7-ELEVEN STORE #42975 SITE #1057022
MAJOR SITE DEVELOPMENT PLAN

MAJOR SITE DEVELOPMENT PLAN
7-ELEVEN - STORE #42975
SITE #1057022
BRADLEY ROAD AND LEGACY DRIVE
COVER SHEET

MAJOR SITE DEVELOPMENT PLAN  
7-ELEVEN - STORE #42975  
SITE #1057022  
BRADLEY ROAD AND LEGACY DRIVE  
SITE PLAN

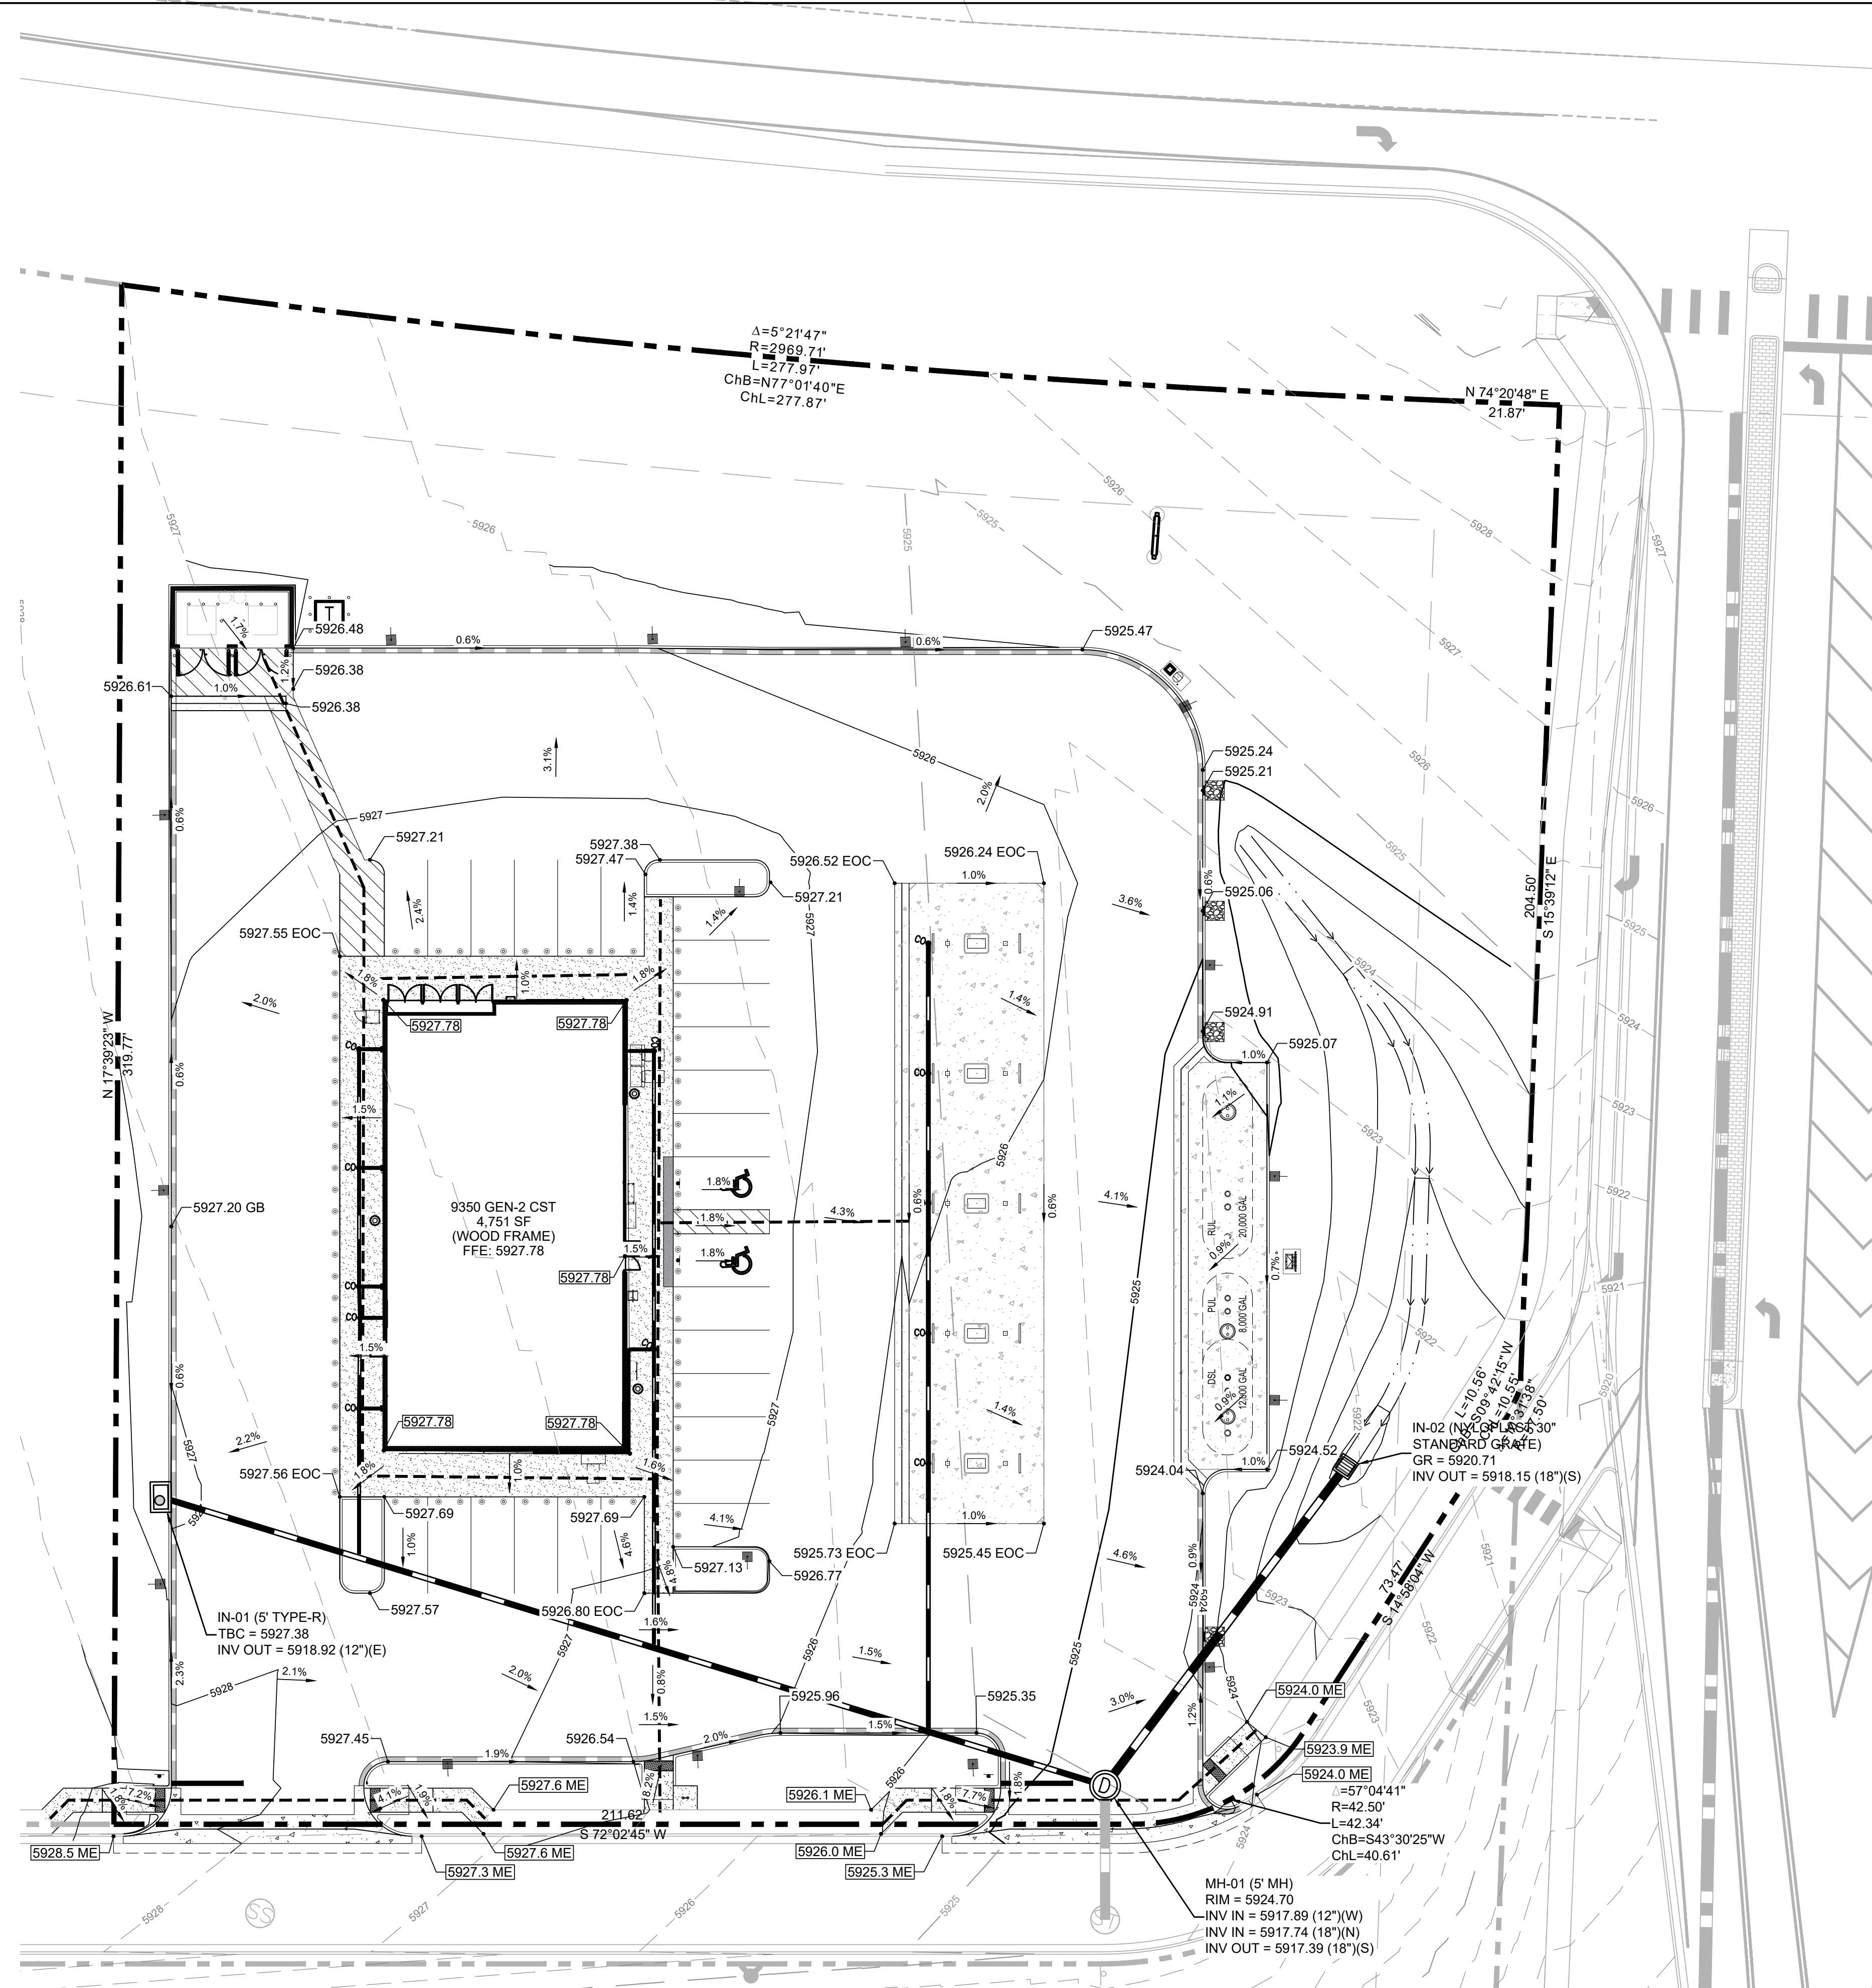
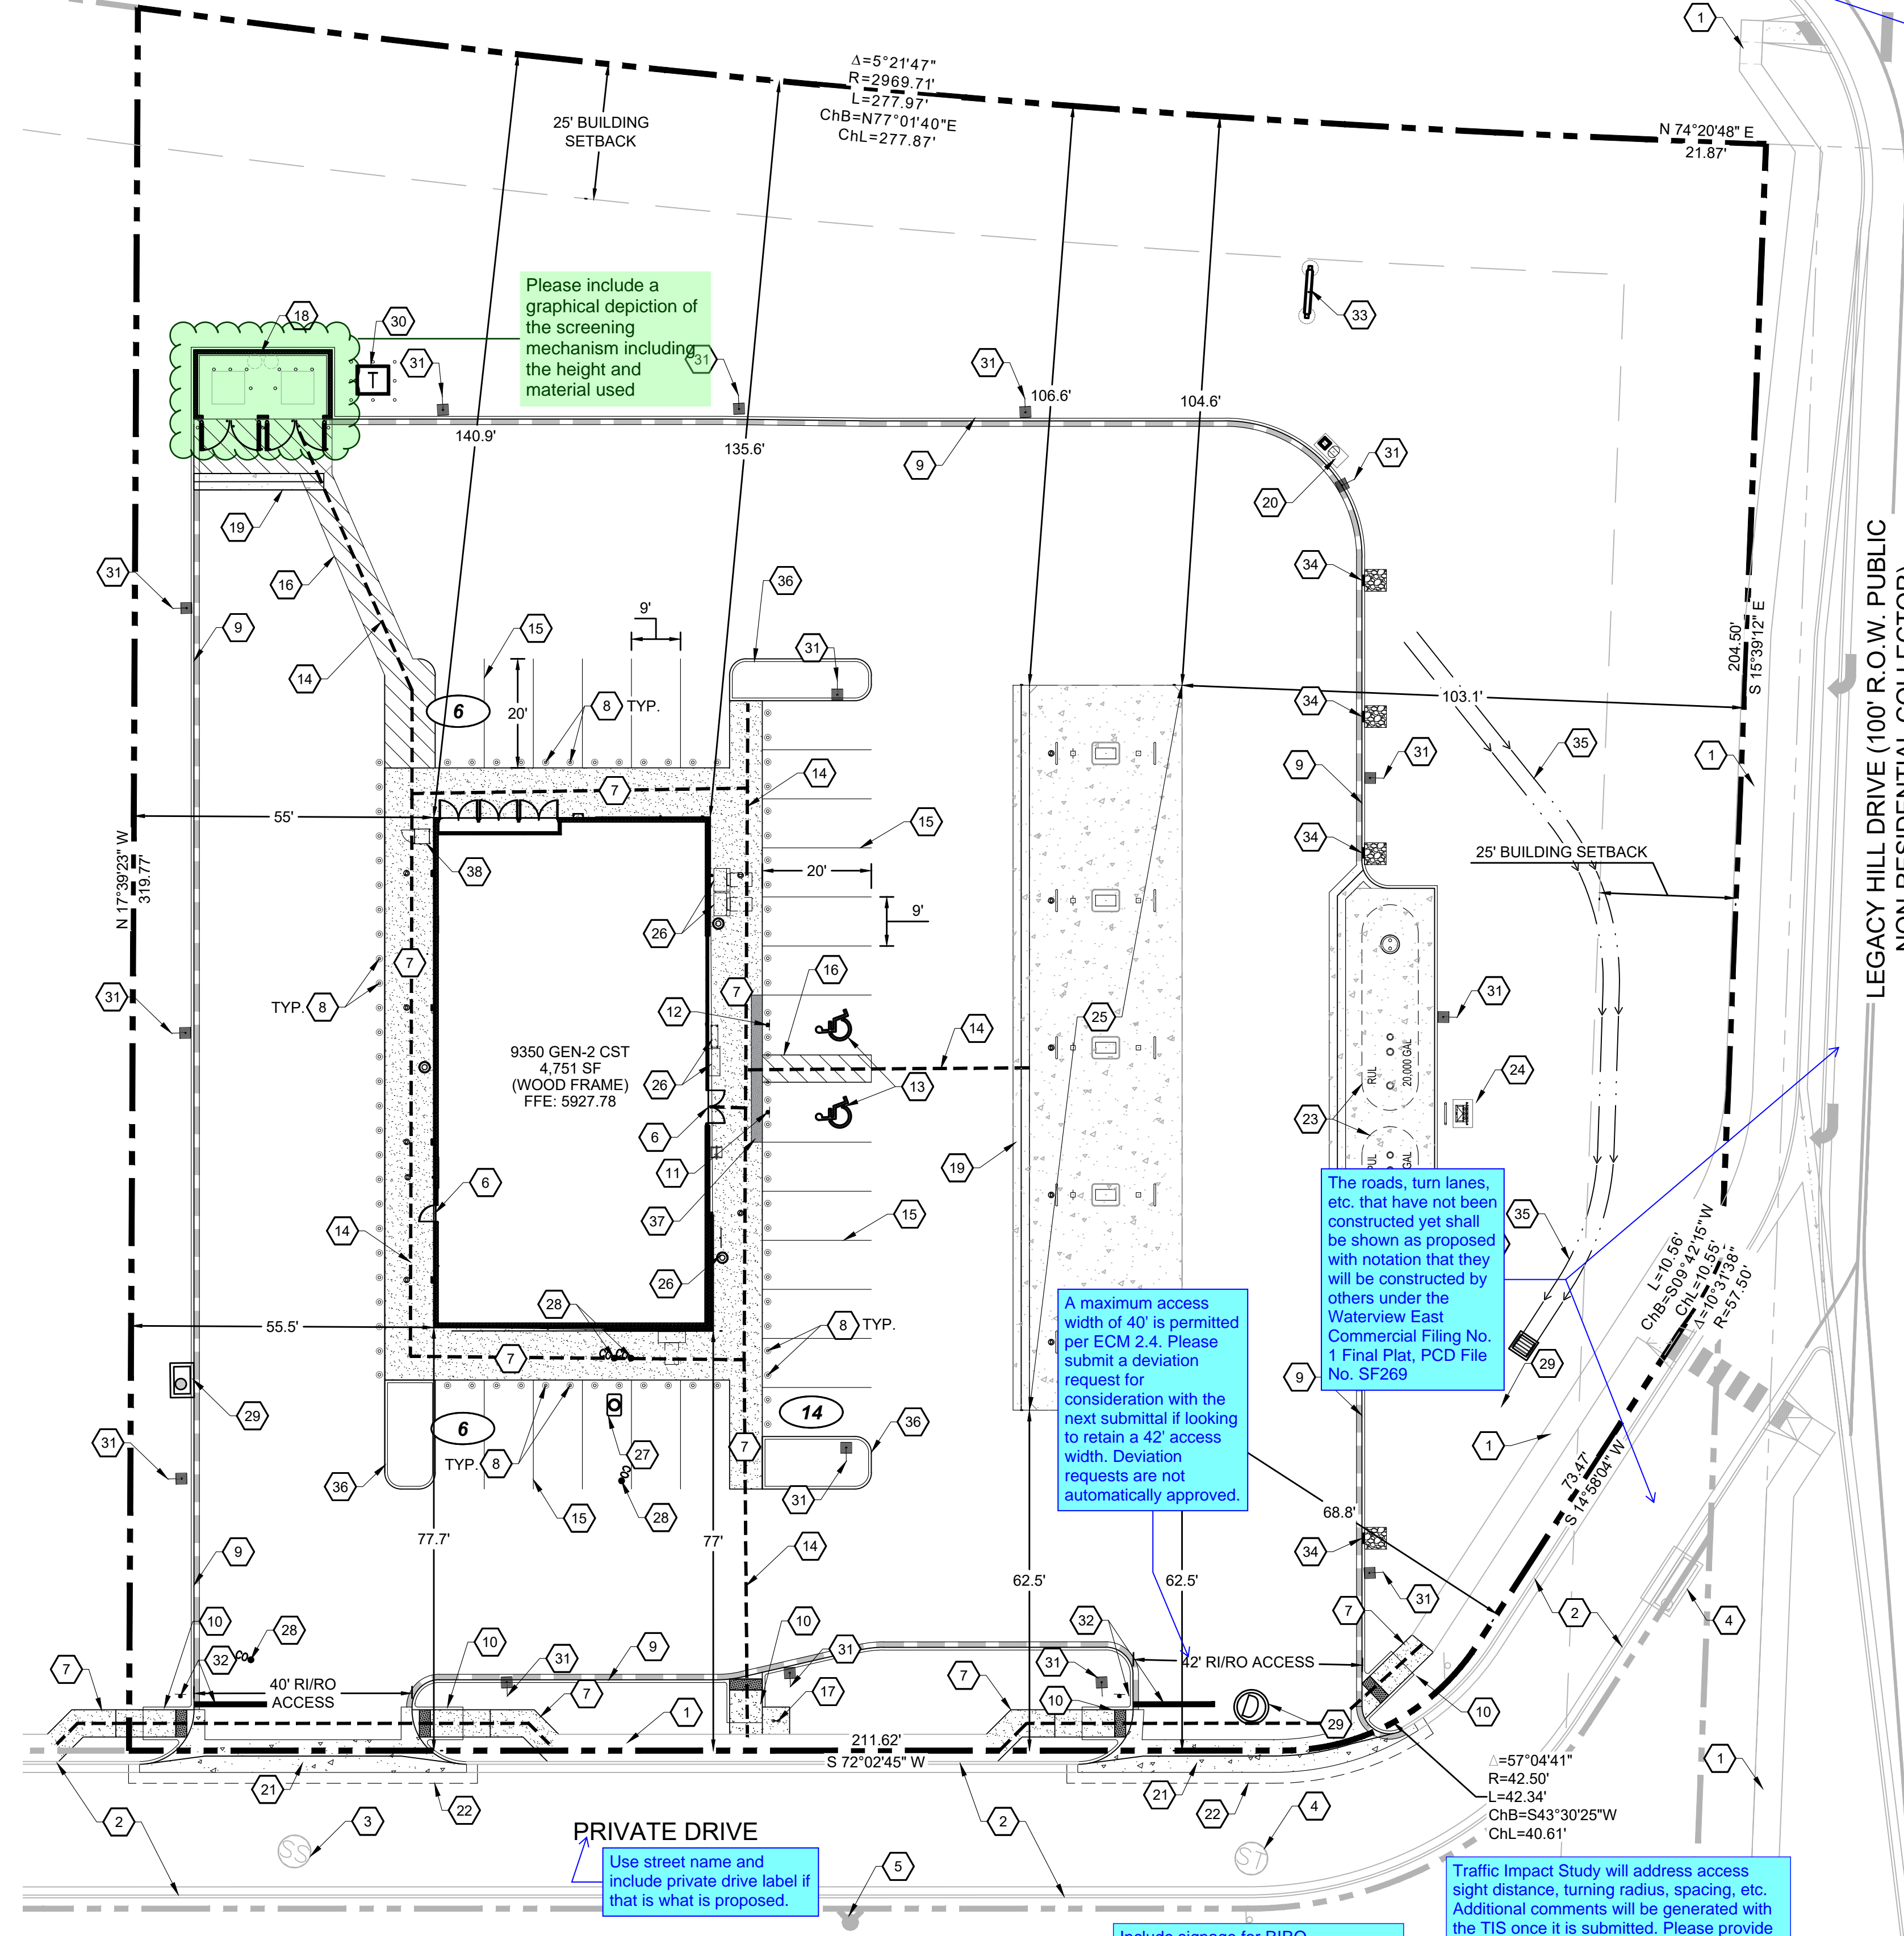
\*\*\*INFORMATIONAL NOTE ONLY\*\*\*  
Please note that the configuration of this lot does not match the approved Preliminary Plan (SP229) and may be subject to reconfiguration of the Final Plat that is still in review (SF269). If the lot configuration is reconfigured back to the approved Preliminary Plan, this Site Development Plan will need to be revised to match.

Note: Depending on if the lot configuration is reconfigured back to the approved Preliminary Plan, engineering may have additional comments in the second review of the site development plan.

Please remove  
crosswalk striping.

Please provide the following information on the site  
development plan:  
-traffic circulation on site  
-location of existing and proposed water/wastewater  
infrastructure  
-location of all existing and proposed utility lines and  
associated infrastructure  
-location and dimension of all rights-of-way and all existing  
and proposed easements.

Traffic Impact Study will address  
sight distance, turning radius, spacing, etc.  
Additional comments will be generated with  
the TIS once it is submitted. Please provide  
Autoturn for this first access in the TIS.

Show calculation based on the Parking Requirements Table (6-2) in the Land Development Code
